Re: Carlsbad Energy Center Project (07-AFC-6)

Responses to City of Carlsbad's Data Requests, Set 1A (#49 - 61)

## Carlsbad Energy Center Project (07-AFC-6)

## City Data Responses, Set 1A

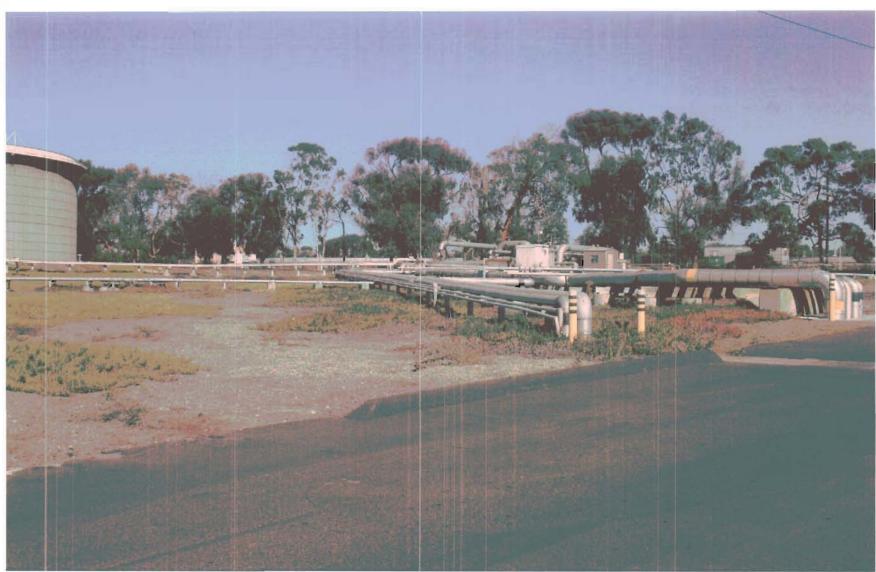
60. Provide lighting plan, including visual depictions, of construction and ongoing operational lighting for proposed power plant, including those contained on the exhaust stacks.

Response: As discussed in Section 5.13.3.2.3 – Visual Resources: Lighting, operation of the CECP will require onsite nighttime lighting for safety and security. Nighttime lighting will be designed to meet security, operation and maintenance, and safety requirements. The lighting will be directed downward and will be downshielded or capped to reduce glare and light trespass. For areas where lighting is not required for normal operation, safety, or security, switched lighting circuits of motion detectors will be provided, thus allowing these areas to remain unilluminated (dark) at most times, minimizing the amount of lighting or glare potentially visible offsite.

As discussed in Section 5.13.3.2.3 of the AFC, during some construction periods and during the startup phase of the project, some activities will continue 24 hours a day, 7 days a week. During periods when nighttime construction or startup activities take place, temporary construction lighting will be provided to meet state and federal worker safety regulations. To the extent practicable, the nighttime construction lighting will be erected pointing towards the center of the site where activities are occurring and will be shielded. Task-specific lighting will be used to the extent practical, while complying with worker safety regulations.

CECP operational lighting design will incorporate the criteria of Section 2.2.13.1 and components of the National Fire Protection Association (NFPA) 70. The primary requirement for each areas lighting design is safety and human factors in both construction and operation environments. A conceptual construction security and lighting plan is shown on Figure City DR60-1 and includes both the specific construction area for the CECP facilities and construction support areas such as equipment and materials laydown areas, rail spur unloading area, rail crossing and temporary south access road areas. The lighting for cranes and other normal high profile construction equipment will include appropriate safety warning lighting.

The conceptual CECP operation lighting plan is shown on Figure City DR60-2 and depicts lighting for operations. The south access temporary road construction lighting and the temporary construction and security lighting around the laydown areas, rail crossing and rail spur will be removed after construction and will return to the existing configuration.

FIGURE DR67c-1
ENCINA POWER PLANT SITE
INTERNAL ROADWAY
EXISTING VIEW AND VISUAL SIMULATION
CARSUBAD ENERGY CENTER PROJECT

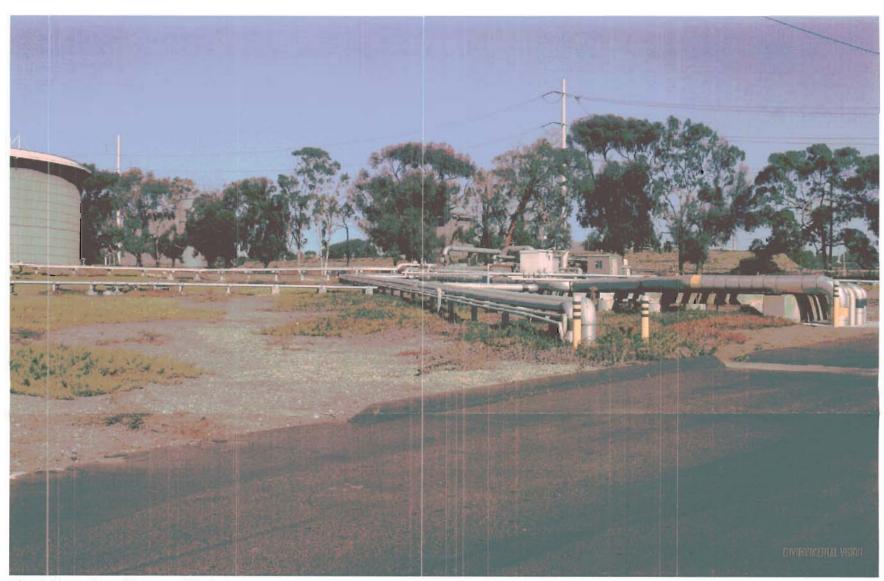
58. Provide visual site depictions of the proposed power plant without the existing oil tanks and Encina Power Station. This includes visual representation from the west side of the railroad tracks looking east at the proposed plant.

Response: While the future redevelopment of the Encina Power Station in accordance with the goals and objectives of the South Carlsbad Coastal Redevelopment Plan is likely to occur upon the retirement and demolition of Units 1 through 5 of the Encina Power Station, it is speculative at this time as to what type of redevelopment (uses, size, scale bulk, orientation) that would result and speculative what public uses and public viewpoints might be developed. Therefore, a specific proposed or anticipated public use area/viewpoint from the site of the existing Encina Power Station westerly of the railroad tracks has not been included.

Notwithstanding the speculative nature of future west side redevelopment, a visual simulation was developed in response to a previous Data Request from the CEC (CEC Data Request 67). In response to CEC Data Request 67, Figure DR67c-1 was developed and included in the Applicant's Data Response Set 1A docketed with the CEC on December 20, 2007. Figure DR67c-1 is provided herein as part of the Applicant's response to this City Data Request 58 (see Attachment City DR58-1). Figure DR67c-1, depicts a "before" and "after" view of the CECP as seen from an internal Encina Power Station road located about 150 feet east of the existing Encina Power Station's administration building (see Figure DR67a-2, provided herein as Attachment City DR58-2, also previously docketed by the Applicant as part of the December 20, 2007 Data Response Set 1A, for the location of this photo viewpoint). The tank shown on the left side of the photograph and simulation on Figure DR67c-1 is Tank No. 3 that would be replaced by the proposed Desalination Plant. While the proposed Desalination Plant will not look the same as Tank No. 3, it will have relatively the same mass and height as Tank No. 3. Therefore, the visual simulation provided on Figure DR67c-1 is representative of the view from this internal Encina Power Station vantage point after construction of the proposed Desalination Project and after construction of the CECP. The simulation on Figure 67c-1 indicates that

from this internal Encina Power Station vantage point, existing Tank No. 3 and the intervening topography and mature vegetation will largely screen the lower elements of the CECP. Taller elements of the CECP, including the 100-foot-tall stacks and 88-foot-tall HRSGs will be partially visible beyond the existing mature trees that are found just west of the railroad corridor that bisects the Encina Power Station property. Because access to the Encina Power Station is and will continue to specifically restricted for public safety and security reasons until such time as the Encina Power Station is demolished, the view presented in Figure DR67c-1 is not currently seen by the public.

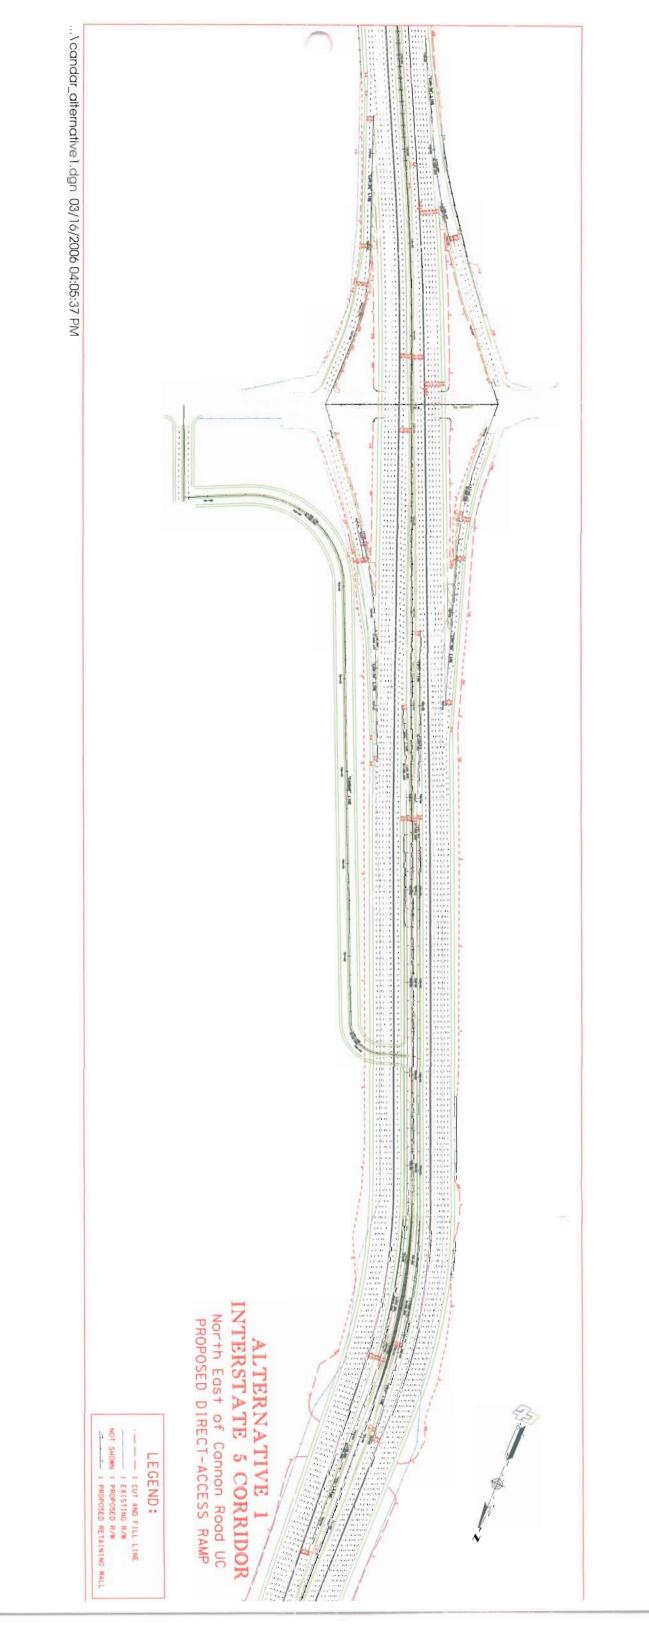
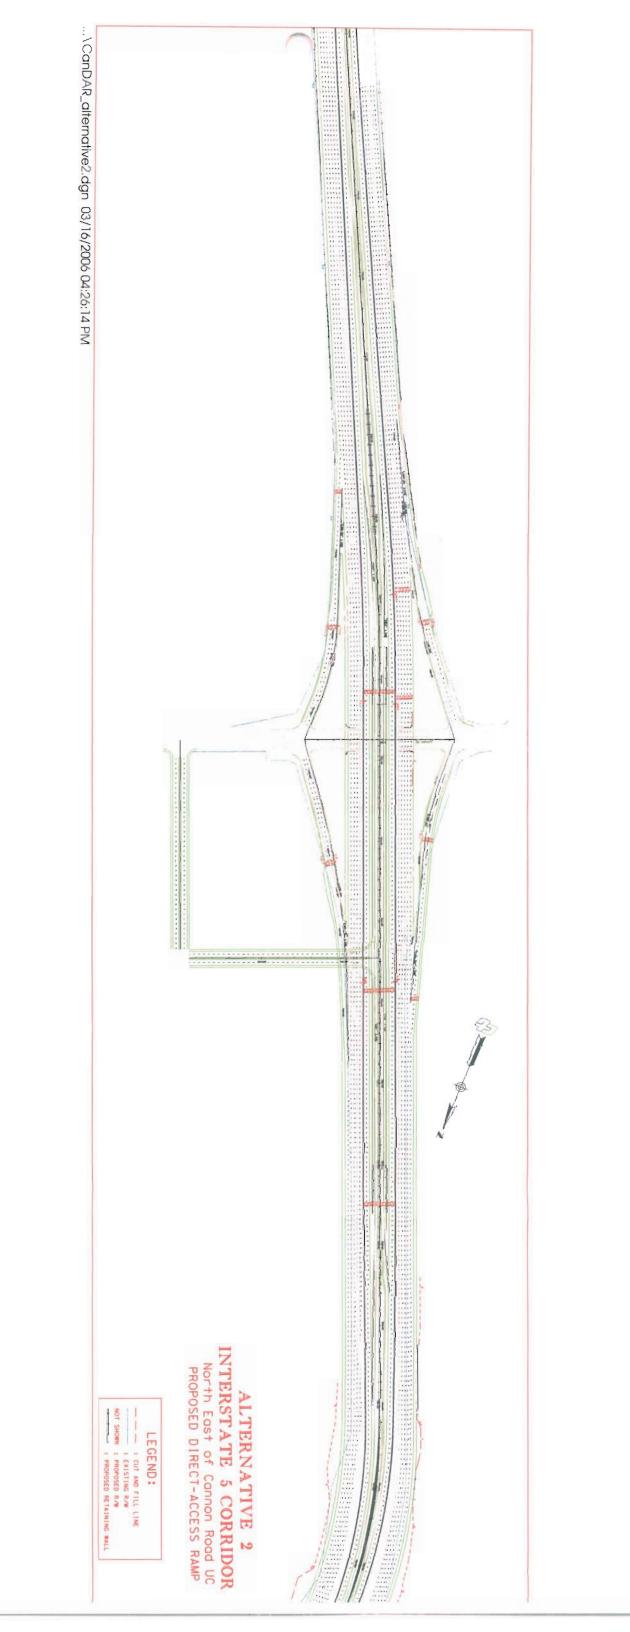
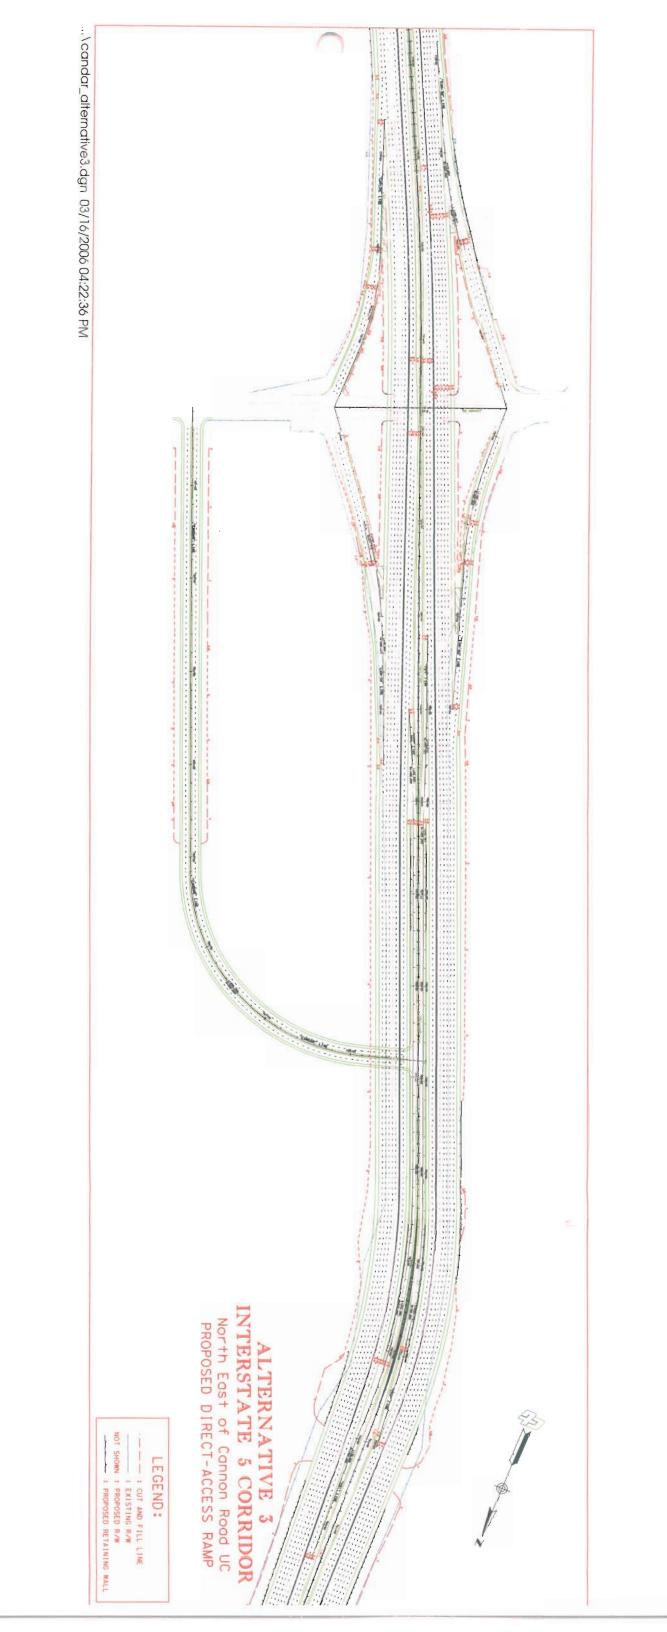
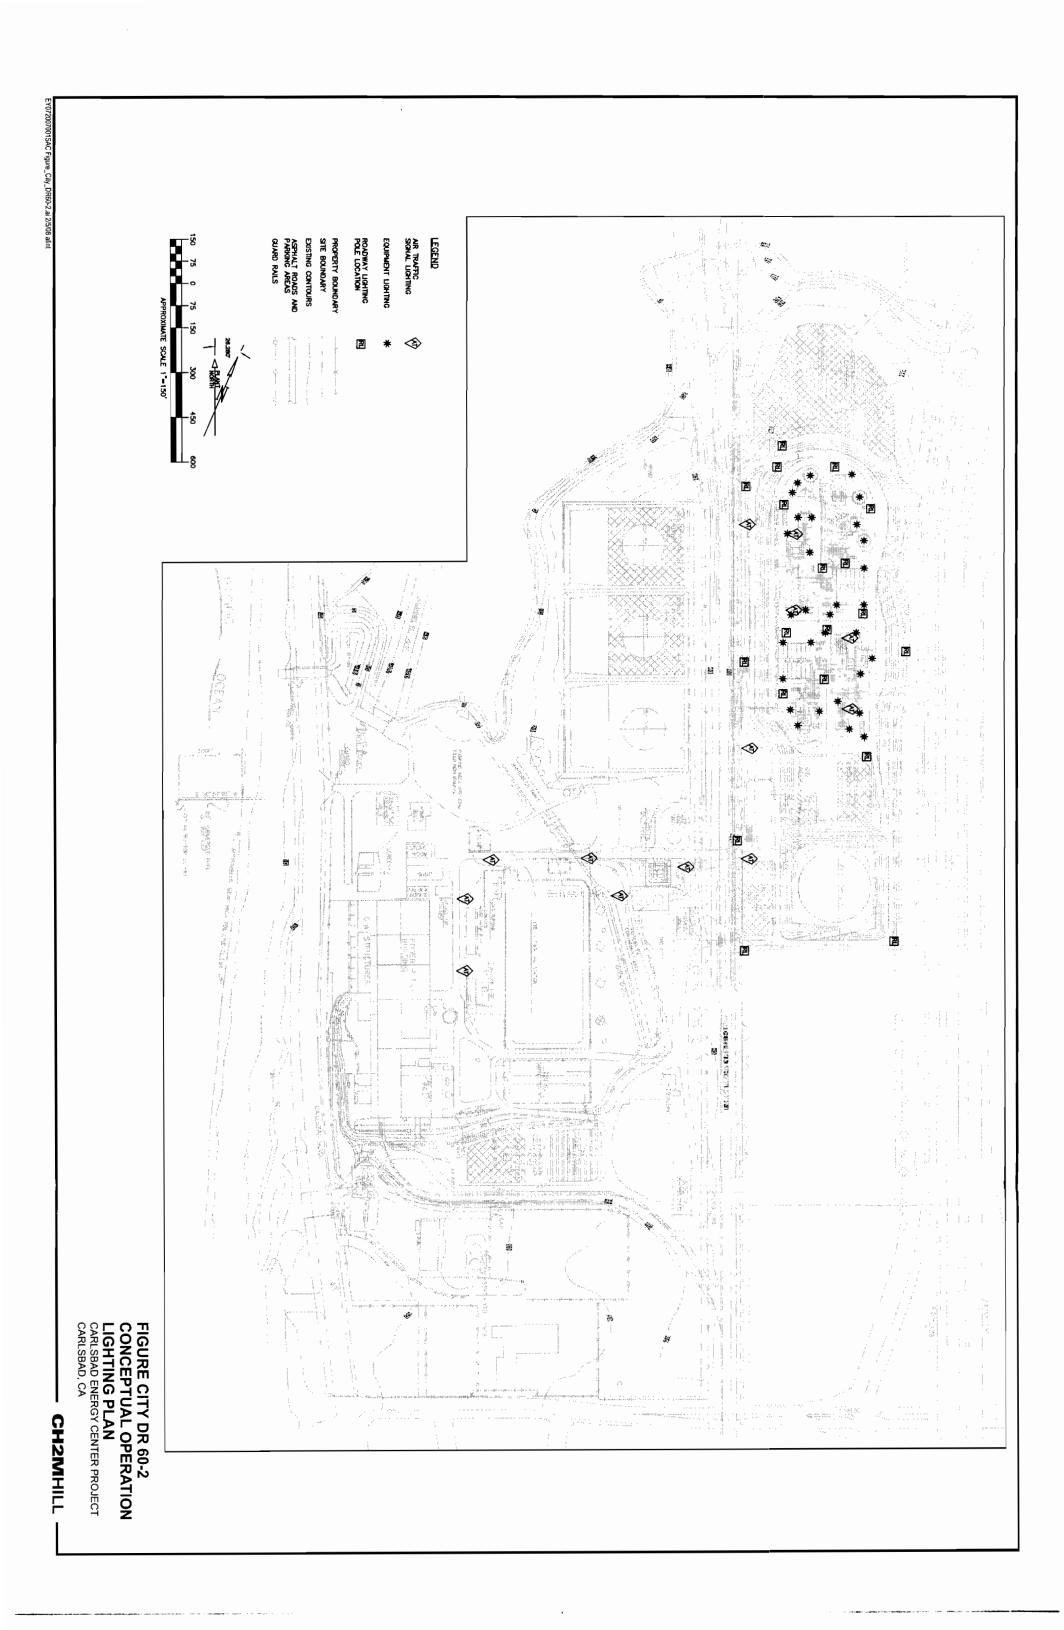
59. Provide visuals from freeway looking west which incorporates the proposed alignment of the I-5 freeway. Incorporate preliminary plans obtained from Caltrans for the I-5 widening in the vicinity of the proposed power plant. Please provide cross-sections from Caltrans throughout the power plant project site. Cross sections should delineate the existing improvements (freeway, slope, containment berm, storage tanks, etc.) as well as indicate the proposed improvements (new pavement, retaining wall, cut-fill slopes). The location of the screening trees should also be shown. Upon these cross sections, the proposed power plant should be shown to provide a graphical representation of the proximity and visibility of the power plants to/from the freeway.

Response: While Caltrans has publicly provided preliminary draft general plan-view maps of four conceptual potential alignments of the proposed I-5 widening project in the vicinity of the CECP site, based on currently available information, the degree of encroachment, if any, that might occur to the CECP property (including the existing vegetation and topographic pattern), as a result of widening the I-5 corridor, is a matter of speculation as the specific alignment has not been selected by Caltrans. Generally, for most of the preliminary re-alignments, it is expected that the area located within the existing Caltrans ROW would be the area most likely affected by the I-5 widening project.

A CEQA/NEPA environmental analysis of the Caltrans I-5 widening project by Caltrans has yet to be prepared, including alternative considerations of the impacts of the four preliminary re-alignments, but it is expected that it will include a detailed environmental impact analysis of the I-5 widening alternatives. It is this CEQA/NEPA environmental analysis by Caltrans that is the appropriate mechanism for the visual analysis of the I-5 widening project selected by Caltrans that is requested by this City data request, as it is the Caltrans I-5 widening project that will create and set the impacts, if any. Based on the preliminary and conceptual nature of the information publicly available at this time regarding the I-5 widening project, there is not sufficient information to prepare the visual simulation requested by the City here. Nor is the Applicant in the position to make the critical judgments necessary to develop representative visual simulations based on the publicly available information.

The City of Carlsbad, in a June 15, 2006 memorandum from the Deputy City Transportation Engineering (see Attachment DR67a-1 provided in response to CEC Data Request 67, docketed by Applicant on December 20, 2007 as part of Data Response Set 1A, and provided herein as Attachment City DR59-1) including the following key goals and objectives of the City regarding the I-5 widening project.

Based on these City environmental goals and objectives for the I-5 widening project and in accordance with the requirements of CEQA, NEPA and the Federal Highway Administration, it is expected that Caltrans' comprehensive environmental analysis of the I-5 widening project will include a detailed, site-specific analysis of potential impacts of the potential loss of the vegetative perimeter berm along the eastern CECP property boundary as well as topographic changes that will occur as a result of Caltrans proposed I-5 widening project in the vicinity of the CECP. The Applicant will coordinate and cooperate with the City of Carlsbad during the I-5 widening project environmental review process to provide input to Caltrans regarding the need for feasible and effective mitigation with respect to minimizing topographic changes and the removal of existing visual screening of the CECP site and the planting of new landscaping on the perimeter vegetative berm on the eastern and northern boundary of the CECP site.
